Access Compliance Report

Public Rights-of-Way

Intersection ID: 29966	Main Street: PANOS_DR	Cross Street: W_W_T_HARRIS_BV	Location: NW
ADA ID: 6411E30D83A3	Ramp Type: Perp	Initial Pass/Fail: Fail	Overall Compliance: No
		Severity Score: 1.25

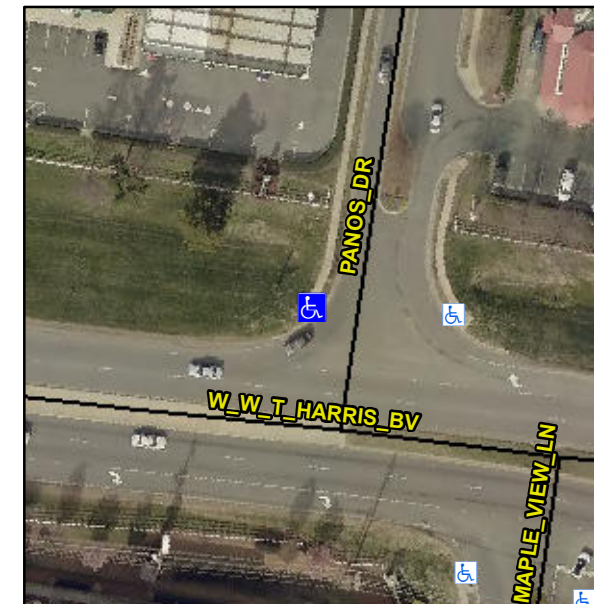
R304.5.3

Compliance	Description	Data	Compliance	Description	Data
N/A	Ramp Length (in)	52.5	Yes	Ramp Slope (%)	6.4
Yes	Ramp Width (in)	49.0	No	Ramp XSlope (%)	3.0
N/A	Flare Type LT	N/A	N/A	Flare Type RT	N/A
N/A	Flare Slope LT (%)	N/A	N/A	Flare Slope RT (%)	N/A
N/A	Flare Traversable LT?	N/A	N/A	Flare Traversable RT?	N/A
N/A	Landing Length (in)	N/A	N/A	DWS Provided?	N/A
N/A	Landing Width (in)	N/A	N/A	DWS Contrast?	N/A
N/A	Landing Slope (%)	N/A	N/A	DWS Length (in)	N/A
N/A	Landing X Slope (%)	N/A	N/A	DWS Full Width?	N/A
N/A	Landing Curb? (Y/N)	N/A	N/A	DWS Offset (in)	N/A
N/A	Shared Landing?	N/A			
N/A	Gutter Ponding?	N/A	N/A	Gutter Slope (%)	N/A
N/A	Gutter Lip Ht (in)	N/A	N/A	Gutter X Slope (%)	N/A
N/A	Painted X Walk1?	No	N/A	Painted X Walk2?	N/A
	X Walk 1 Direction	To E		X Walk 2 Direction	N/A
N/A	X Walk 1 Width (in)	N/A	N/A	X Walk 2 Width (in)	N/A
	X Walk 1 Slope (%)	0.8		X Walk 2 Slope (%)	N/A
	X Walk 1 X Slope (%)	5.2		X Walk 2 X Slope (%)	N/A

Remove & Replace Entire Ramp.
